Re: Indian Point Unit No. 2  
Docket No. 50-247

Response to NRC's October 26, 1984  
Questions on the Indian Point No. 2  
Pump and Valve Inservice Testing Program

Consolidated Edison Company of New York, Inc.  
Indian Point Unit No. 2  
Docket No. 50-247  
October, 1985

<p>CONSOLIDATED EDISON CO. INDIAN POINT UNIT 2</p>
<p>Figure 5.2-27 Containment Isolation System Penetration Schematics</p>

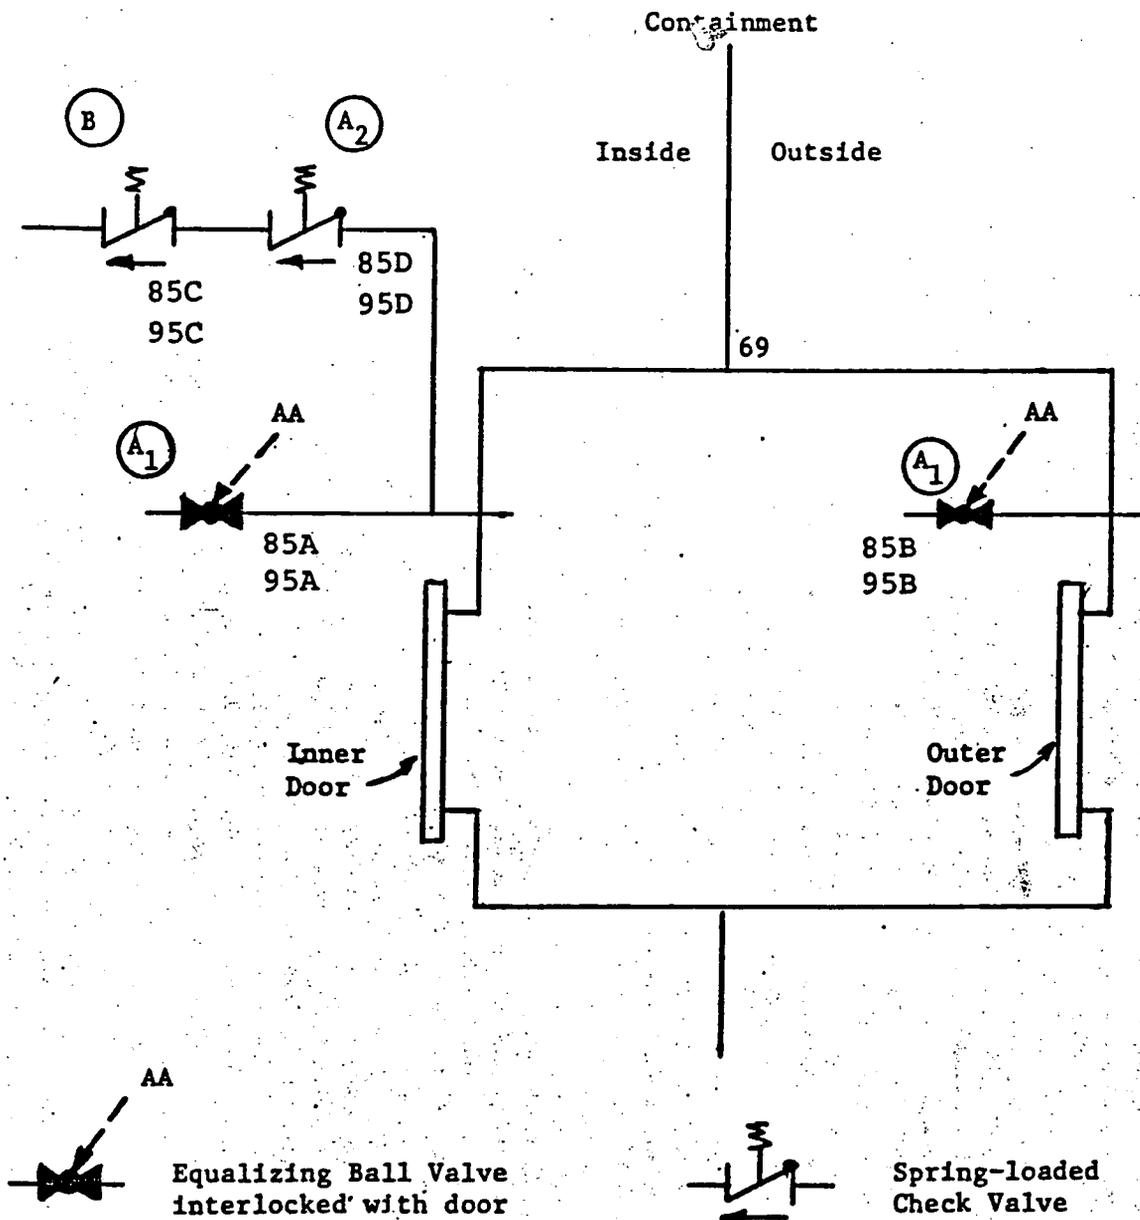
1. P&ID 9321-F-7052-9 was not supplied, therefore we are unable to review the valves listed in this system.

FSAR figure 5.2-27 enclosed depicts the subject valves. A revised summary sheet referencing this figure will be provided.

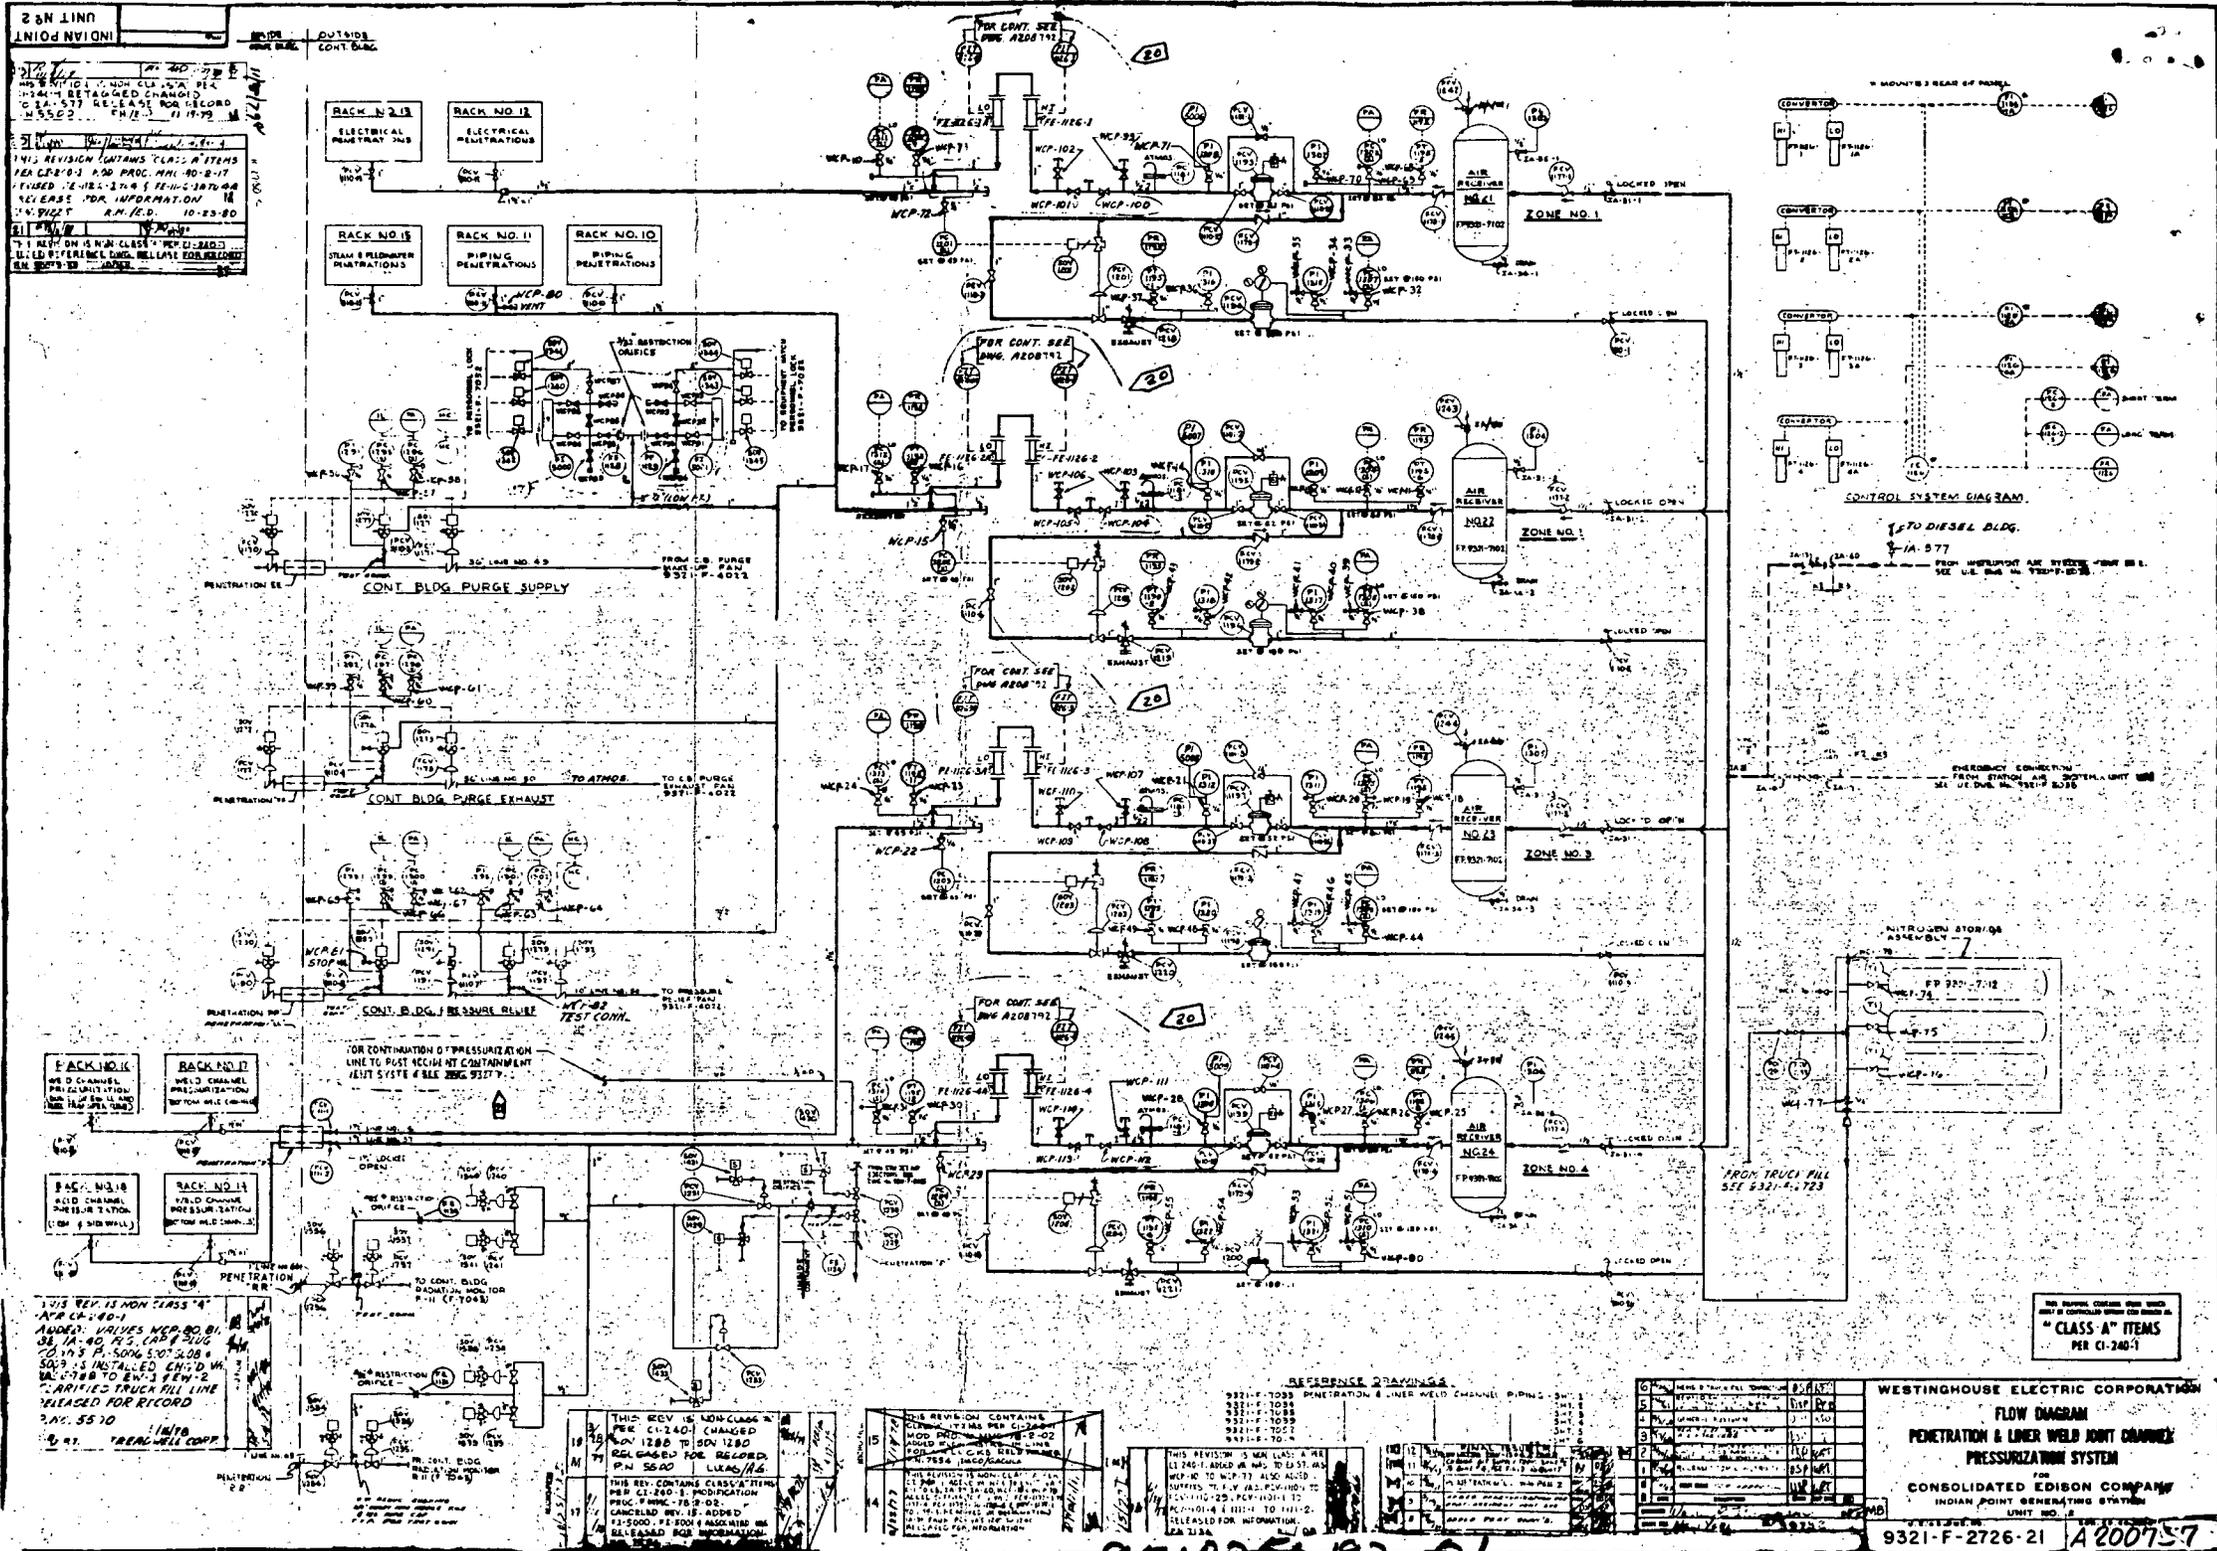
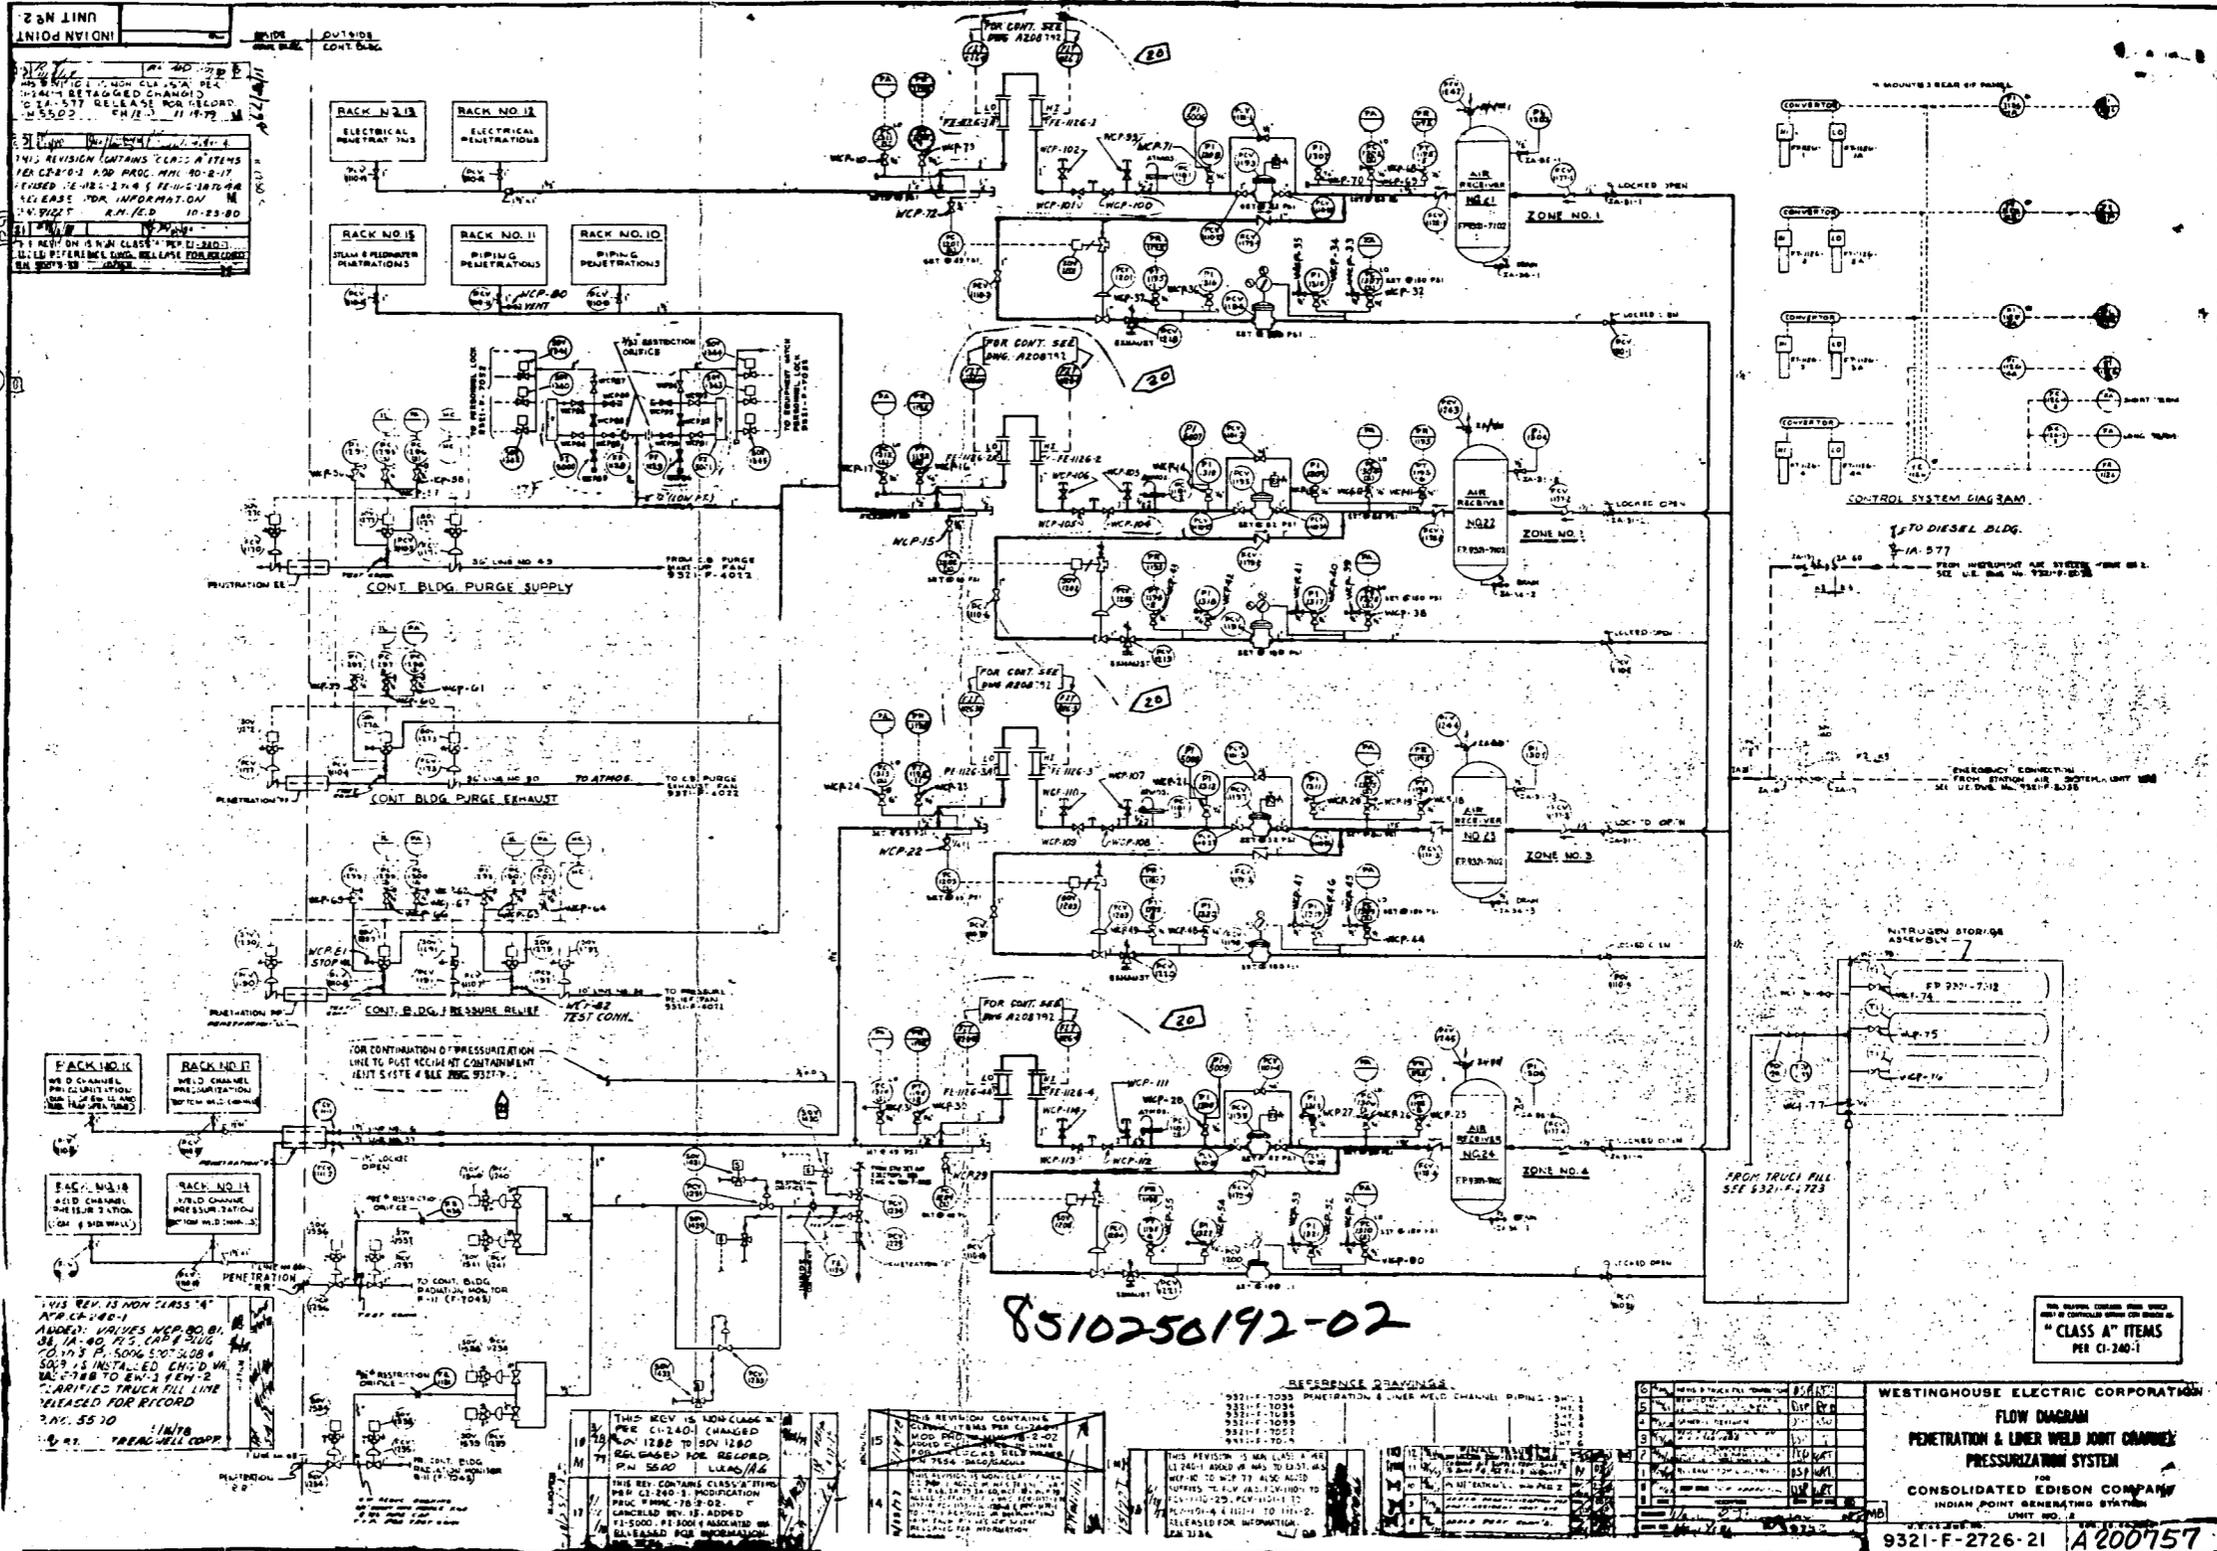
1. The valves listed in this system are not located on drawing 9321-F-7052-10, sheet 5, therefore, we are unable to review this system.

The subject valves are located on drawing 9321-F-2726. The latest revision of this drawing is enclosed. Revised summary sheets reflecting the proper drawing are being provided.
